**Highways England: A303 Amesbury to Berwick
Down Project, Development Consent Order
Application**

Scheme Reference: TR010025

**Summary of oral submissions at ISH 10:
Flood risk, groundwater protection, geology and
land contamination**

**The Stonehenge Alliance
(Reference No. 2001870)**

Figure 2 “Chalk Stratigraphy with Tunnel and Chalk Rock Elevations (adapted from Mortimore (2012))” and used in Highways England Document REP3-019

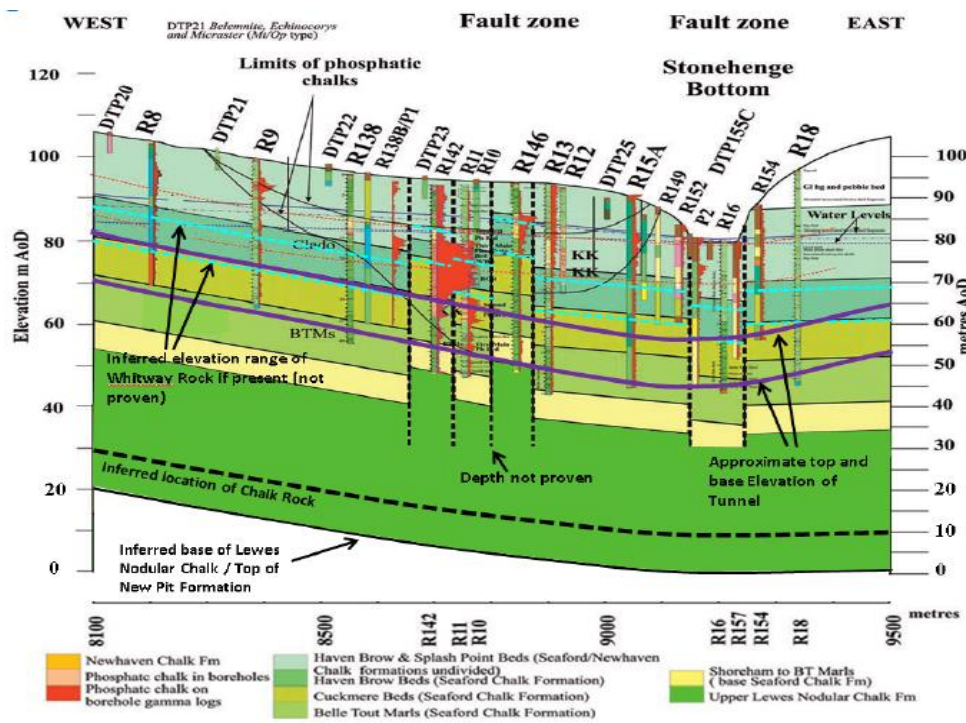
7. [Slide 10] The geological cross-section produced by Highways England at Fig.2 in their Deadline 3 *Implications of 2018 Ground Investigations to the Groundwater Risk Assessment* (REP3-018) (reproduced below) is noteworthy. The section shows where the Whitway Rock was expected to be and the proposed tunnel line. The geology in Stonehenge Bottom is obviously extremely complicated, with massive vertical fractures. It is proposed to place the tunnel within or partly within the Whitway Rock and the horizon of high permeability above it. See levels in Slide 13: Boreholes R13 and R11, where I interpret the Whitway Rock Horizon to be at the tunnel soffit level as proposed.

In examining the detail of groundwater and lithological data relating to the Whitway Rock Horizon, it was noticed that Highways England had used a dated figure (Fig.2), attributed to Professor Mortimore in his 2012 Glossop Lecture (see reference and Fig.2 reproduced below). It remains uncertain if the AWM groundwater modellers have superimposed the correct profile of the proposed tunnel (as defined in the HEng A303 Amesbury to Berwick Down Project Documents APP-010 and APP-019 (Engineering Section Drawings) on their Figure 2.

The groundwater levels and postulated zone range of the Whitway Rock horizon are also problematic (see figure below) as explained in Dr Reeves' presentation to the hearing.

Fig.16a (“The control boreholes used to establish the stratigraphical position and thicknesses of the chalk beds and the phosphatic chalks. . .”) from Mortimore et al. 2017, for comparison with 2012 section used by Highways England, above

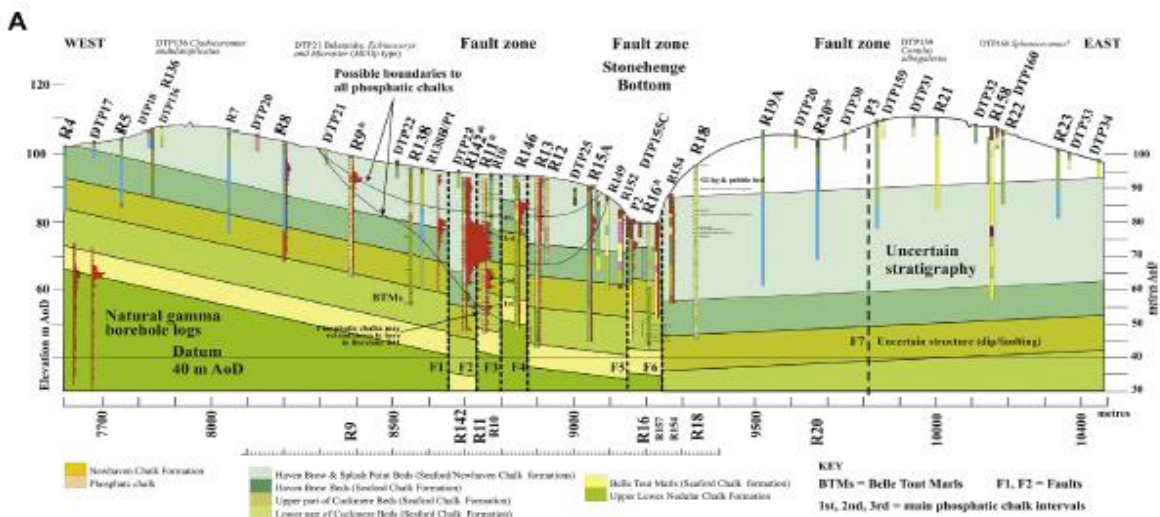
In view of a presumably much more recent (and radically different in its eastern part) section drawing of the geology across Stonehenge Bottom by Professor Mortimore et al. (2017, Fig.16a; reproduced for comparison at end of this submission), there is no obvious reason nor any explanation why Mortimore's 2012 section is used and represented in AWM Report No. TR010025 Document 8.23 – Implications of 2018 Ground Investigations to the Groundwater Risk Assessment (REP3-019) republished with tracked changes, dated 31.05.19):
